8. Well Name and No.
PURE GOLD MDP1 29-17 FED COM 171H9. API Well No.
30-015-45716-00-X110. Field and Pool or Exploratory Area
WILDCAT-WOLFCAMP11. County or Parish, State
EDDY COUNTY, NM**SUBMIT IN TRIPLICATE - Other instructions on page 2**

OXY USA Inc. respectfully requests to amend the approved drill plans with the following changes:

Oxy USA Inc. – Bulk Sundry
PURE GOLD MDP1 29-17 FED COM 171H, 172H, 173H, 174H and 175H

1. Summary of Changes

TMK UP TORQ™ DQW

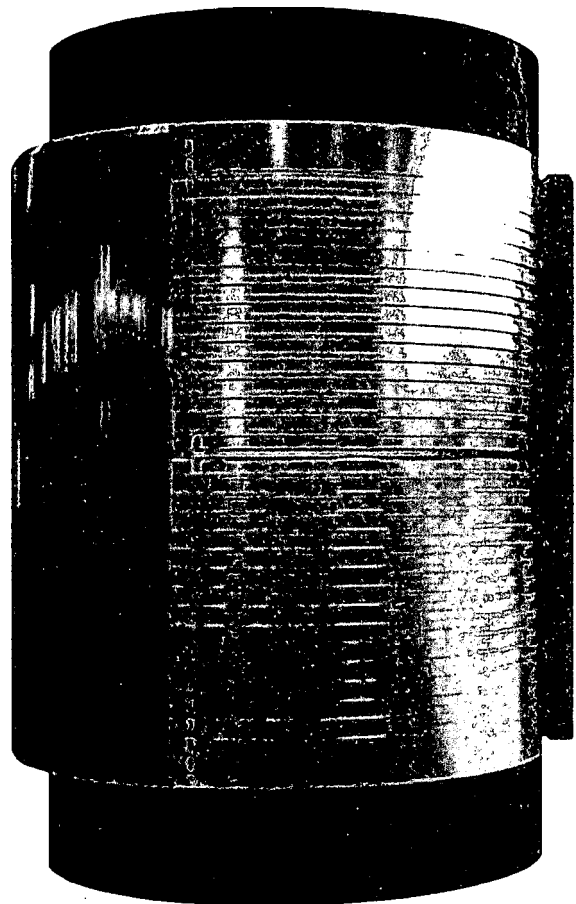
1. Changing 9-5/8" casing weight from 43.5ppf to 40ppf ?h
2. Changing Deep intermediate hole size from 8.5" to 8.75" ?h
3. Changed 7-5/8" SF from 4000" to 6000" ?h
4. Updated cement calculations based on new casing and hole sizes
5. Option to run production casing with DQW TORQ connections to accommodate hole conditions
6. Option to cement 9-5/8" and/or 7-5/8" intermediate strings offline (now in drill plan)

*Oxy requests the option to run production casing with DQX, SF TORQ, and/or DQW TORQ connections to accommodate hole conditions or drilling operations.
